SUBMITTAL SUMMARY REPORT ImpOffSite-000754-2026

PLAN NAME: Water Main Extension and Cnnx - Duplex	LOCATION: 14160 SW 60TH TER OCALA,
APPLICATION DATE: 05/11/2026	PARCEL: 8009-1270-08
DESCRIPTION: 70 ft extension of an existing 6" water main. This Project is for Marion County Utilities and Planning review only. The Project is located on SW 60th Terrace in Marion Oaks to serve a proposed duplex.

**Waiver Request for
Offsite Improvement Plan for 14160 SW 60th Terrace Watermain Extension
PID#8009-1270-08
Application #ImpOffSite-000754-2026**

WATERMAIN EXTENSION PLAN

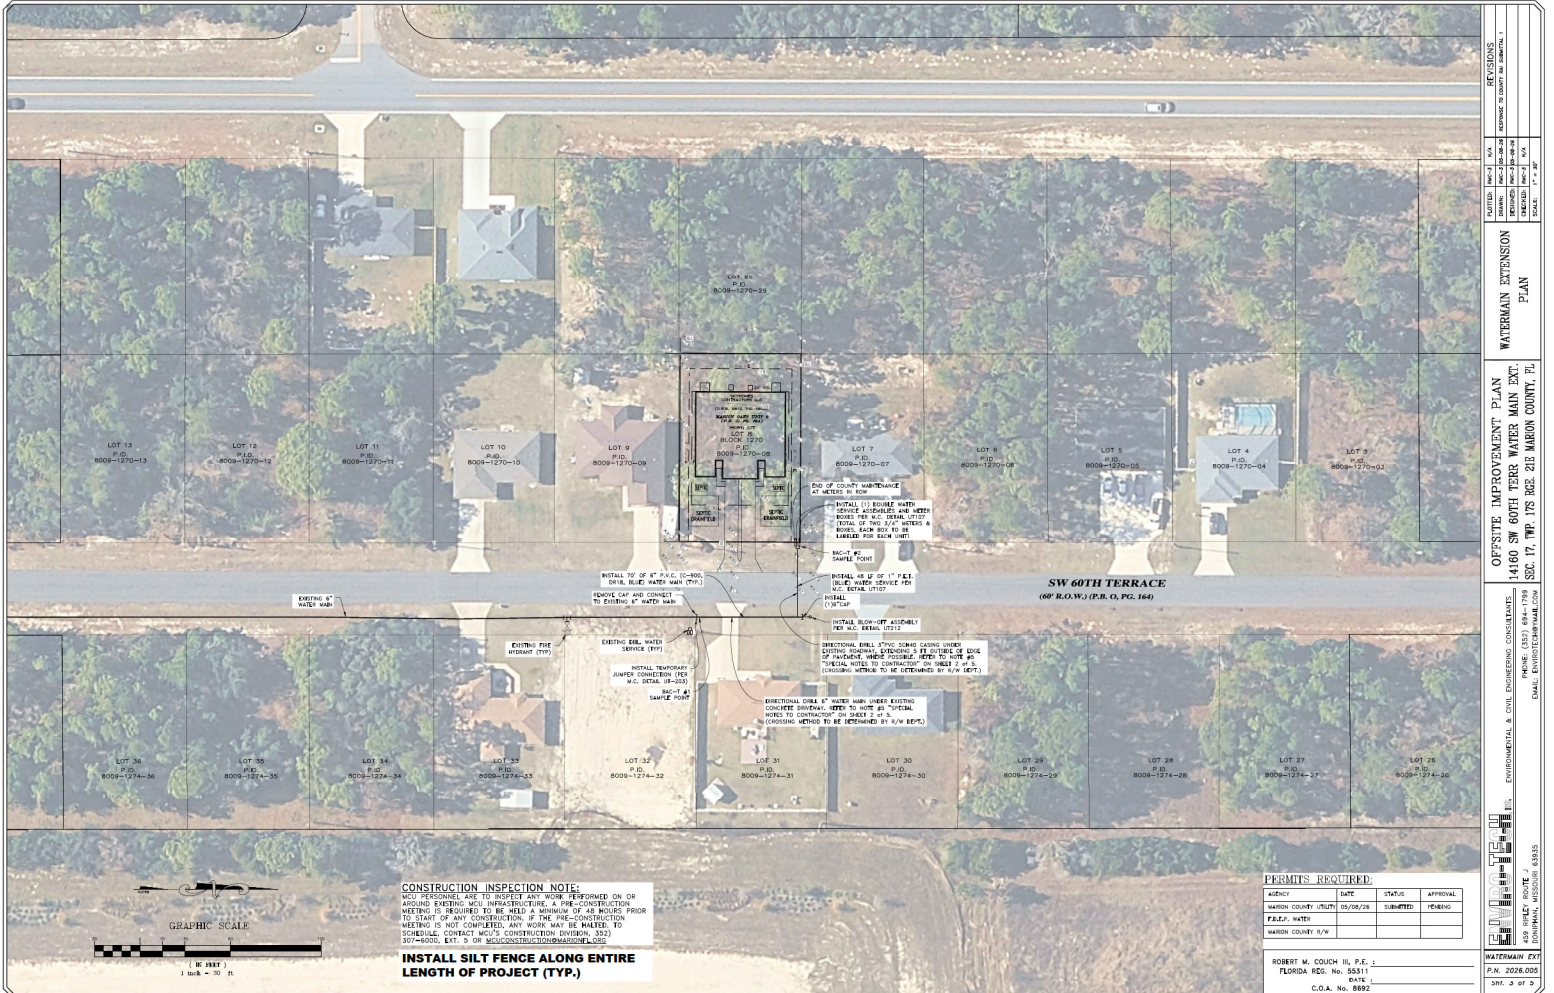
OCE Traffic (Permits & Plans) (Office of the County Engineer)		06/23/2026		Pending Assignment
Utilities (OCE Plans) (Utilities)	Heather Proctor	06/23/2026		Pending Assignment
<i>Corrections</i>	6.15.6.A - Potable Water Metering - loc/bank/size (Not Resolved) - Corrective Action: Sheet 3: Call out meter sizes. (2) add end of county maintenance at the water meters in ROW. - 6.15.6.A - Potable Water Metering - loc/bank/size:			
<i>Corrections</i>	6.15.7 - Cross Connection Control/Backflow (Resolved) - Corrective Action: No backflows proposed. - 6.15.7 - Cross Connection Control/Backflow:

<i>Corrections</i>	6.15.5 - Water Service & Connection (Not Resolved) - Corrective Action: Sheet 3: Call out casing going under the road, or plumb in C-900. (2) 2" water service is not required for a double service. Reduce to 1". (3) Need blow off at the end of water main extension. - 6.15.5 - Water Service & Connection :
